**VILLAGE OF DOWNERS GROVE  
REPORT FOR THE VILLAGE COUNCIL MEETING  
NOVEMBER 2, 2010 AGENDA**

SUBJECT:	TYPE:	SUBMITTED BY:
Lot Consolidation and Special Use for Automobile Repair Facility at 212 Ogden Avenue	<ul style="list-style-type: none"> <li>✓ Resolution</li> <li>✓ Ordinance</li> <li>Motion</li> <li>Discussion Only</li> </ul>	Tom Dabareiner, AICP Community Development Director

<b>SUBJECT:</b>	<b>TYPE:</b>	<b>SUBMITTED BY:</b>
PC-10-10 212 Ogden Avenue	Final Plat of Subdivision & Special Use for an Automobile Repair Facility	Damir Latinovic, AICP Planner

PROPOSED SITE PLAN  
 SCALE: 1/16"=1'-0"

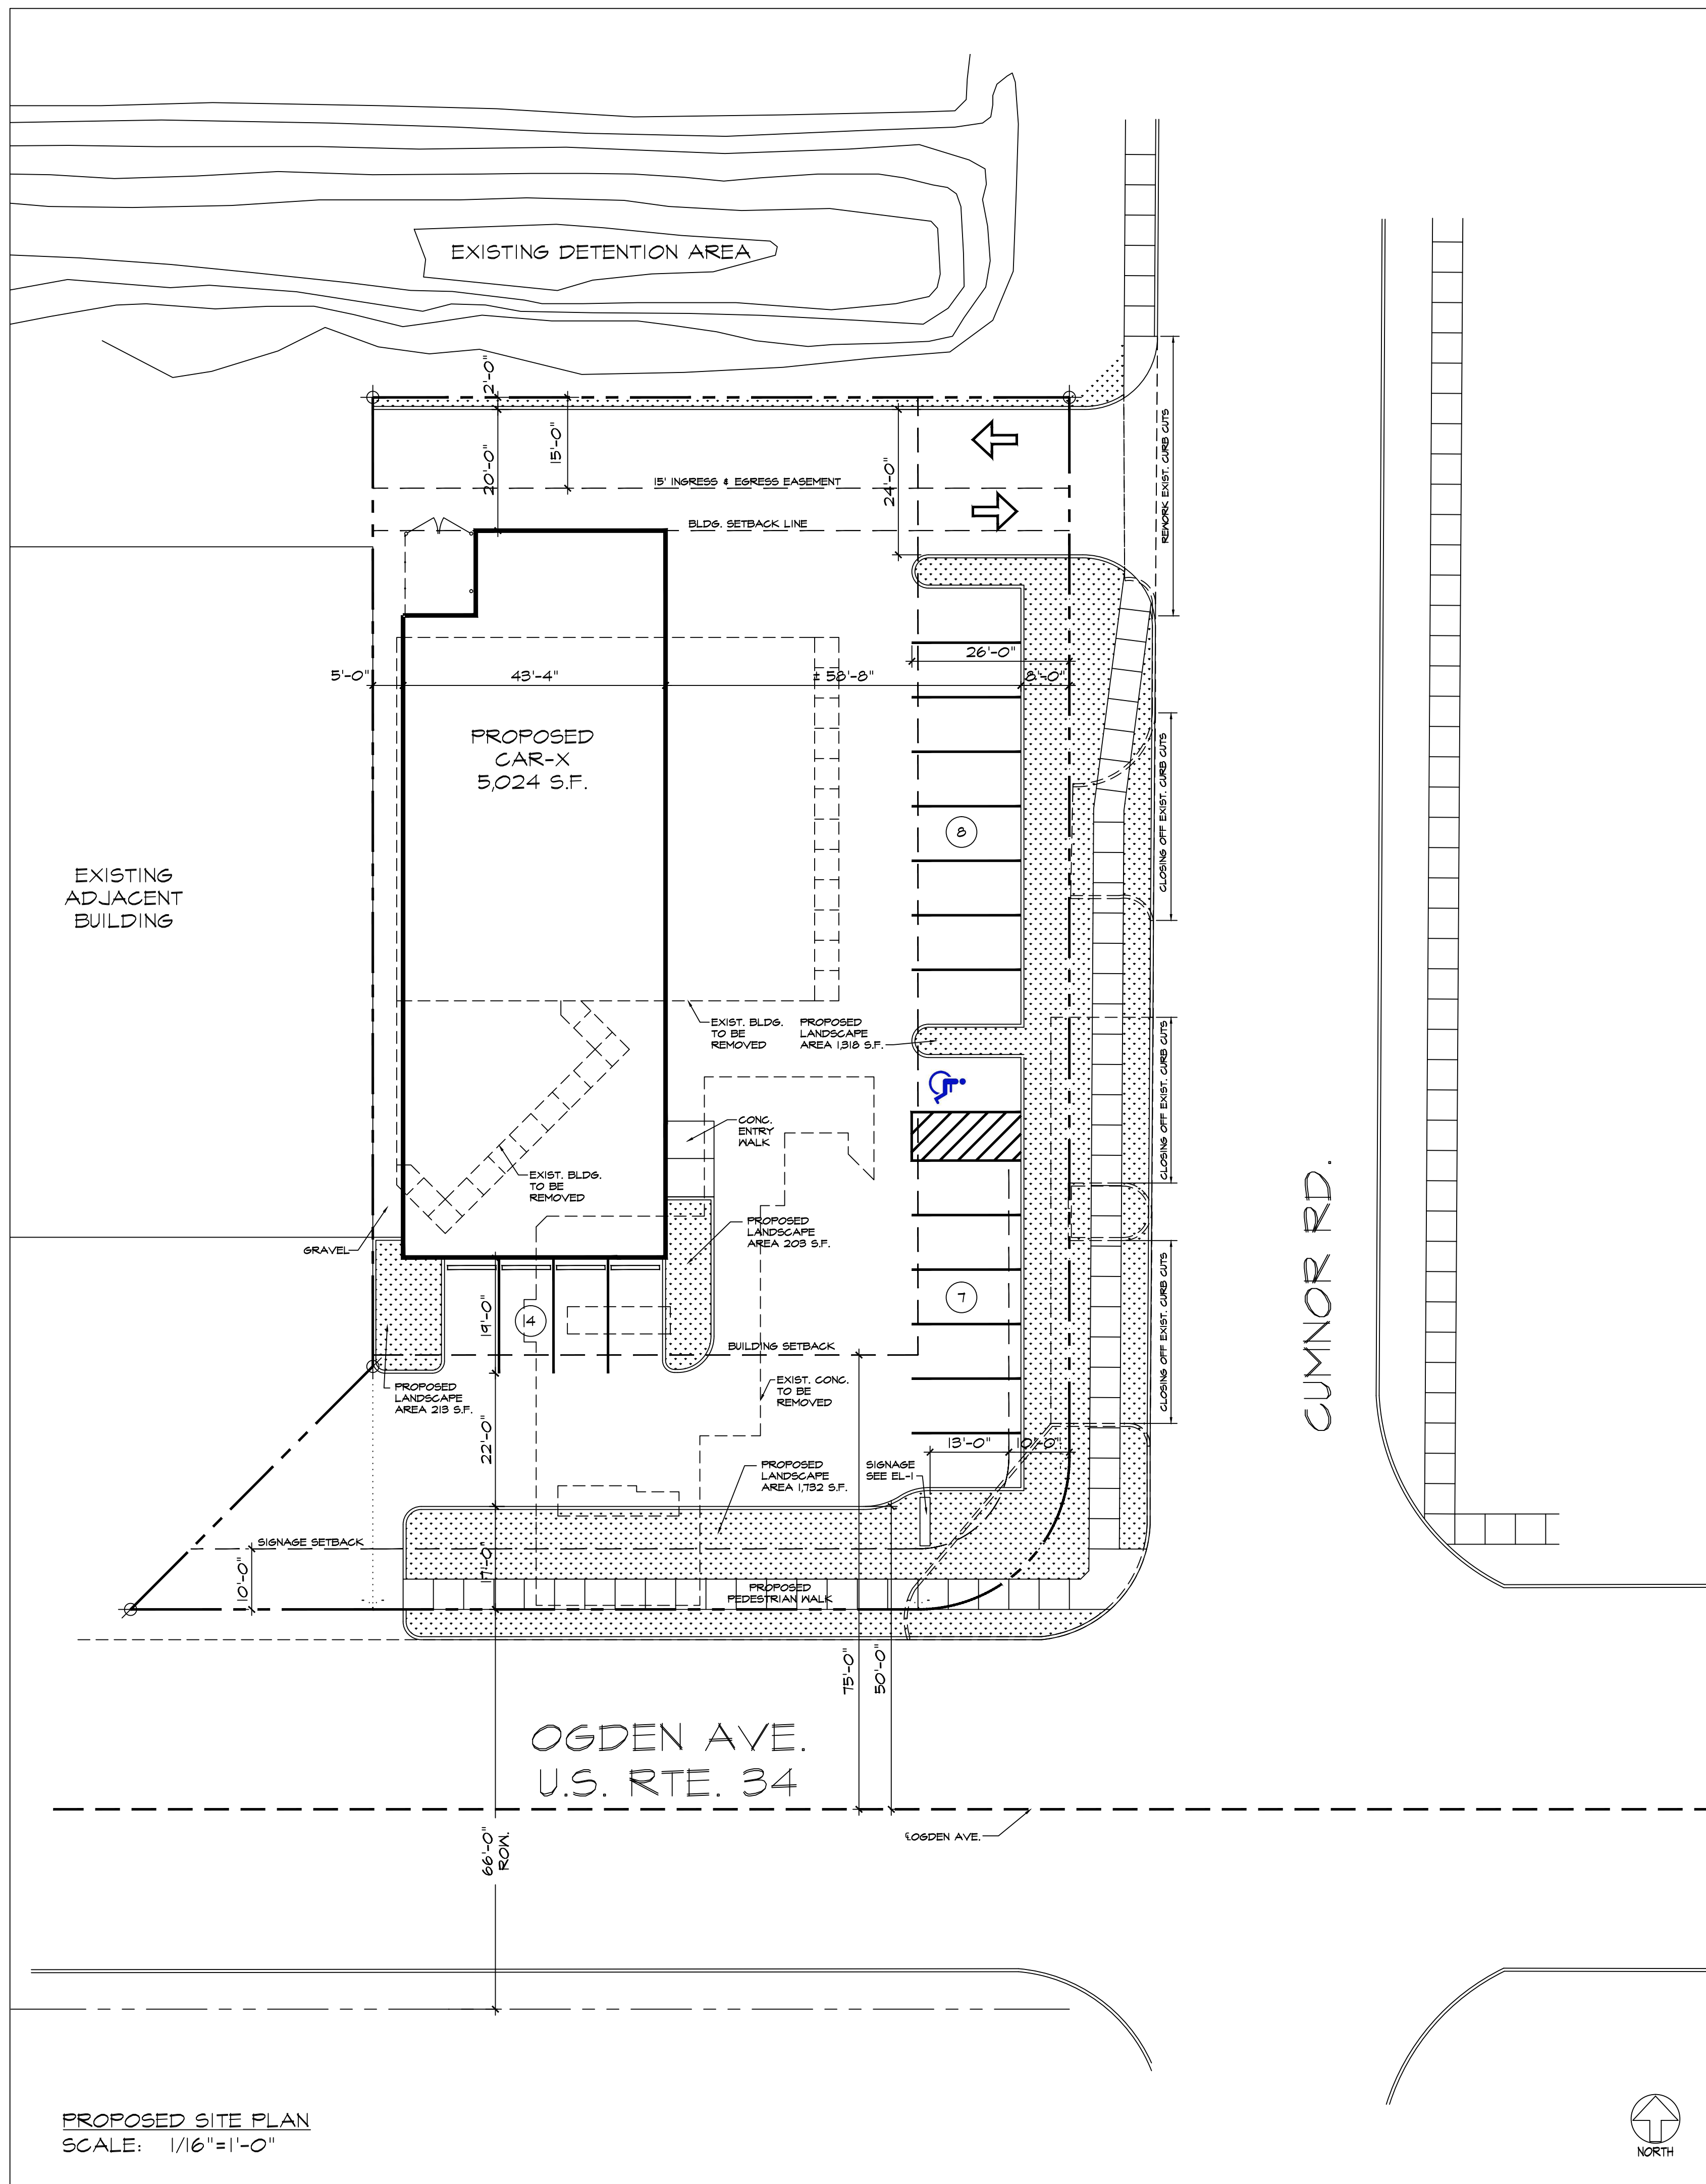
To further improve the drainage on the property, the proposed site plan will have to be revised to include pervious large stone or gravel material in the five-foot wide area west of the proposed building. A new curb and gutter will also have to be installed around the proposed landscaped island south of the building.

8. "No Parking-Fire Lane" signs shall be installed on the north side of the building and indicated on revised plans.
9. The proposed public sidewalk along Cumnor Road shall be relocated to the west to provide a minimum five-foot wide green space parkway between the roadway and the new sidewalk.

LANDSCAPE PLAN

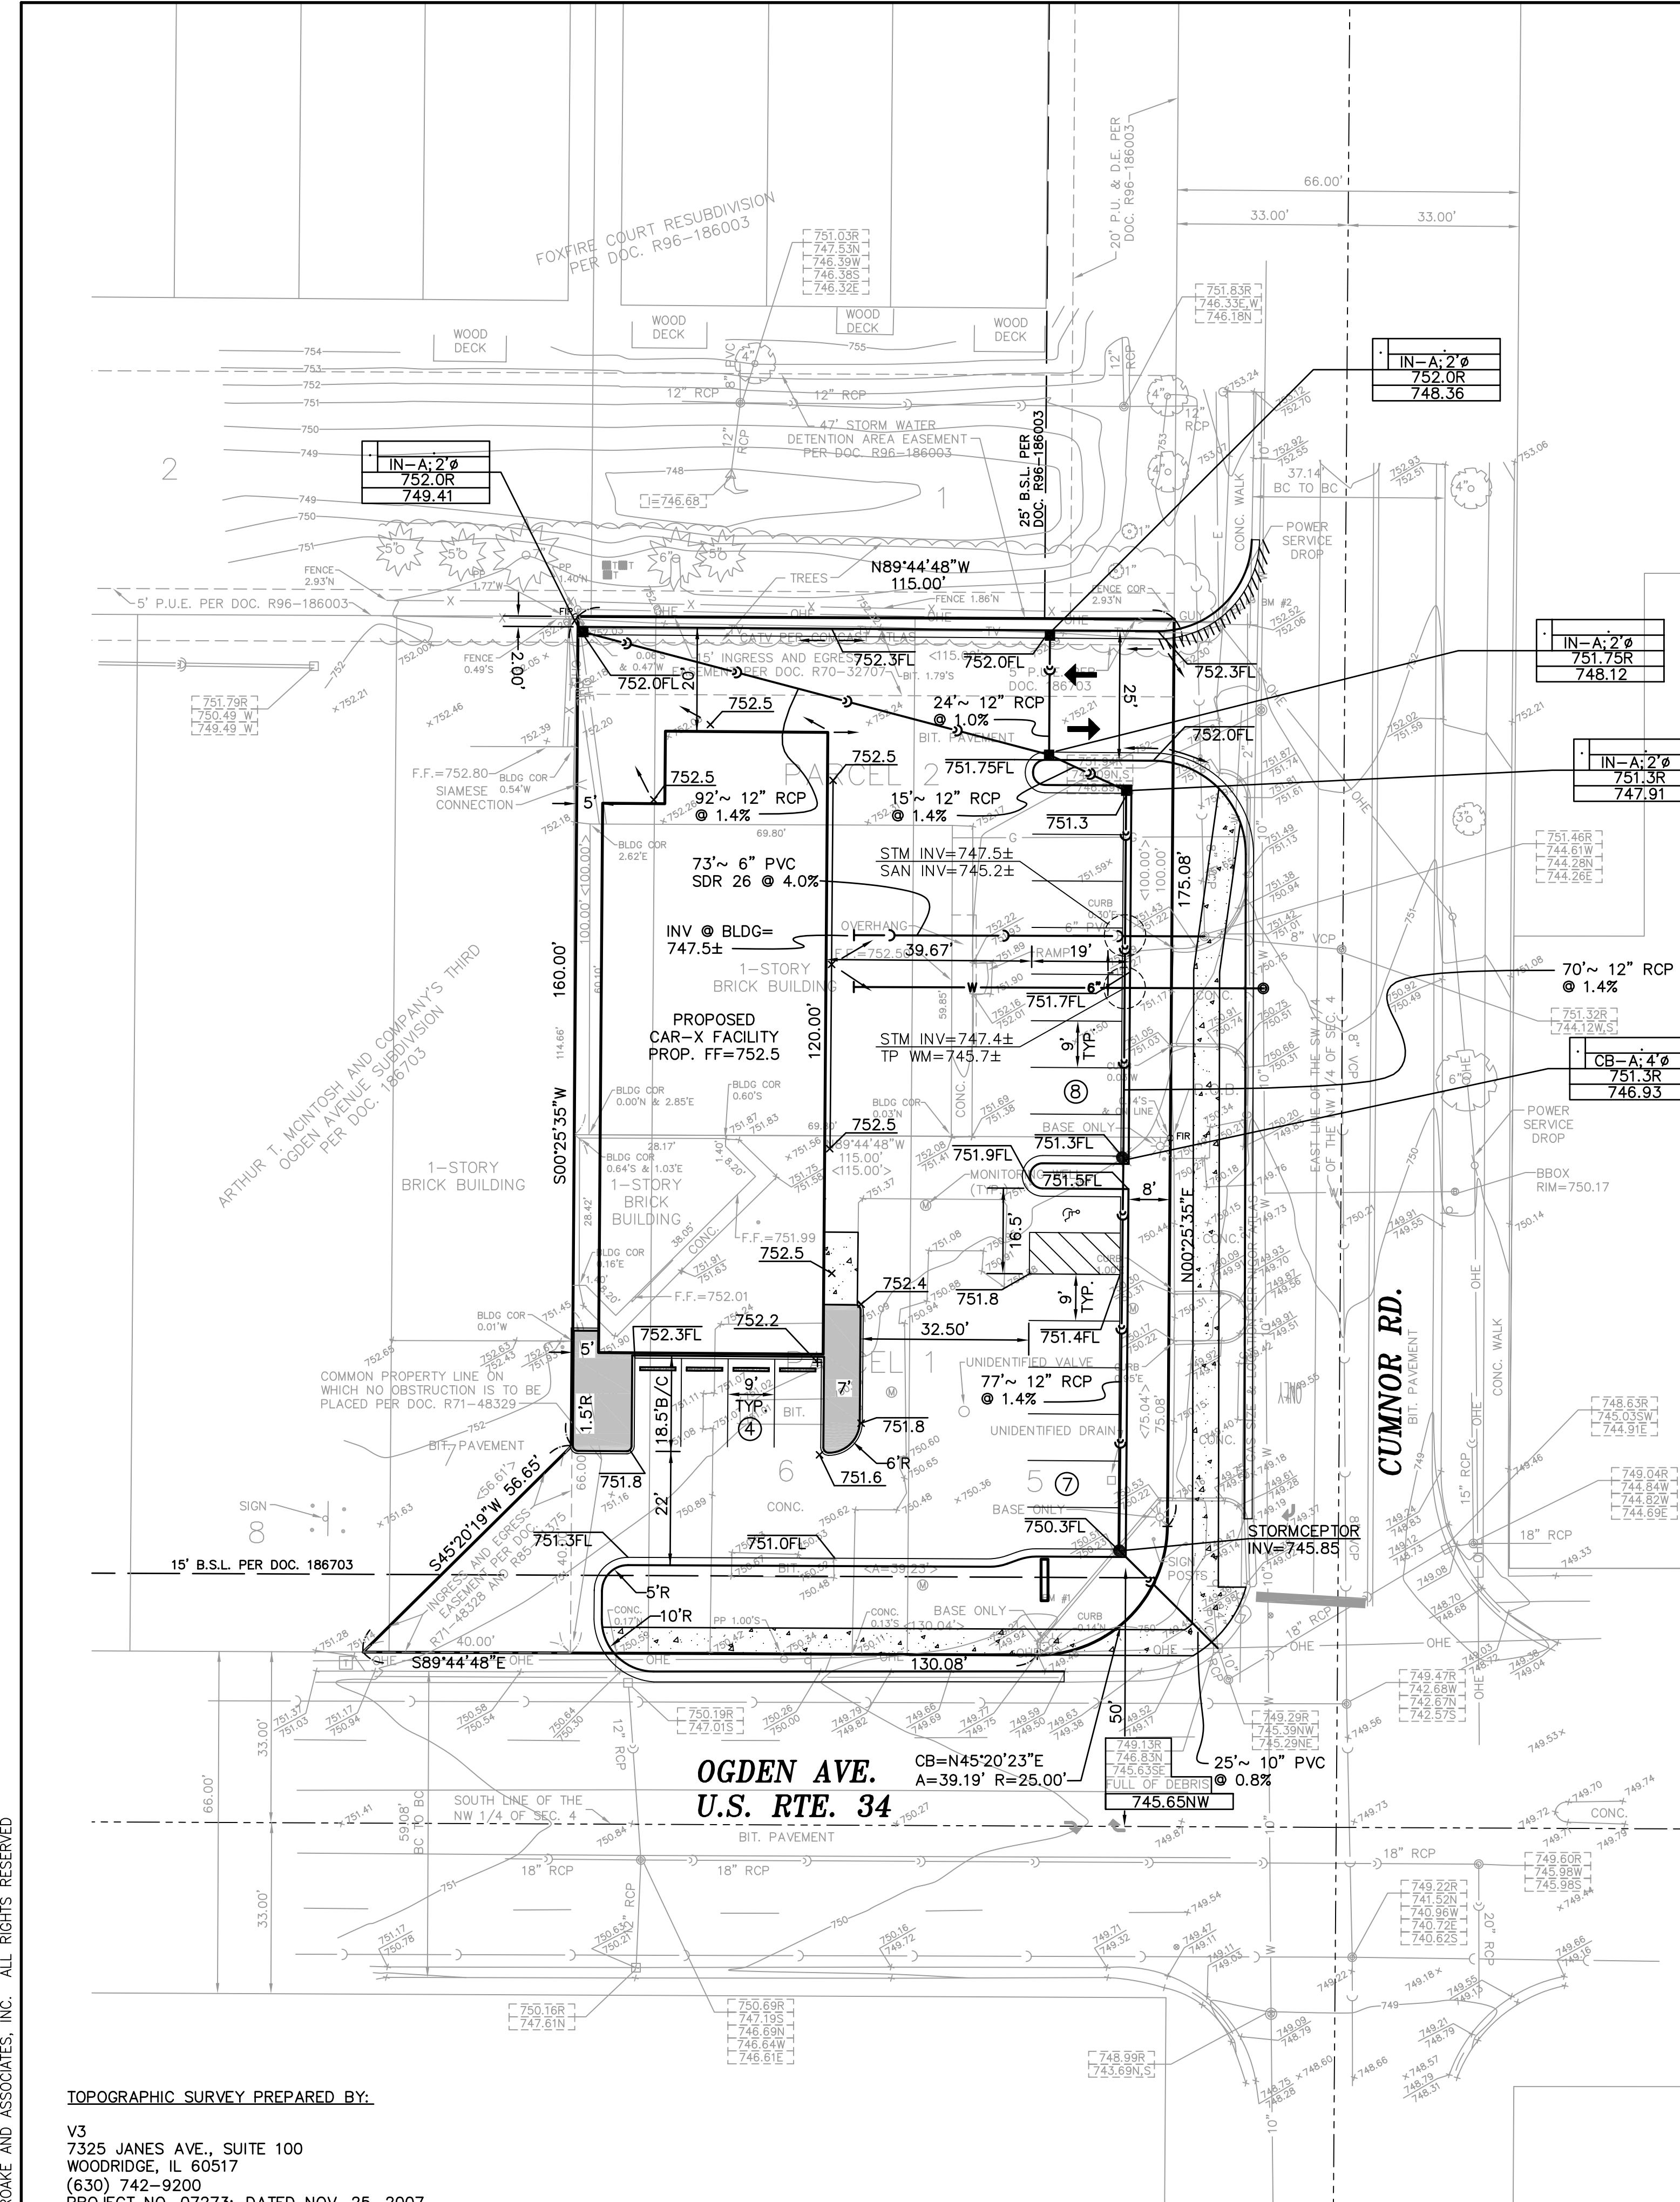
5. The proposed landscape plan shall be revised to include shrubs instead of tall grass plants along the north property line.
6. The building shall be fully sprinkled with a NFPA 13 system by a state of Illinois registered sprinkler contractor. (2007 NFPA 13 and IBC Table 903)

- 18. THE PETITIONER SHALL INSTALL MORE DENSE EVERGREEN PLANTS ALONG THE NORTH PROPERTY LINE SUBJECT TO THE APPROVAL BY THY VILLAGE FORESTER.**
- 19. NO PUBLIC ANNOUNCEMENT SYSTEM SHALL BE USED ON THE SUBJECT PROPERTY, 212 OGDEN AVENUE.**
